**Report: TAB Report**  
**Function: Test, Adjust, & Balance**  
**Date: 12/09/2025**  
**Completed By: National TAB**

**PROJECT**  
**11-24-25 Freddys - Tulsa, OK**

Project: 11-24-25 Freddys - Tulsa, OK

Asset: HD1

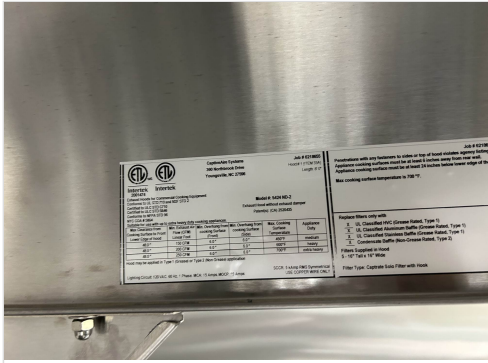
**Issue Name :** Hood 1/KEF 1 CFM low  
**Description :** CFM low below design (66%) at FLA. Ductwork, hood and fan were inspected for possible causes. Ductwork was found to be the most likely culprit. Ductwork contains two T junction ducts and one 90 degree duct. The motor on KEF-1 is 1 HP and is likely struggling with a non direct vertical duct system. Further investigation by mechanical required.

- **12/09/2025 National TAB - Cody Collett**
  - Issue still present 12/08/2025. Hood capture 100% in current conditions with exception of 1 incident reported by management that the hood was not capturing at all but has had no other in incident since.
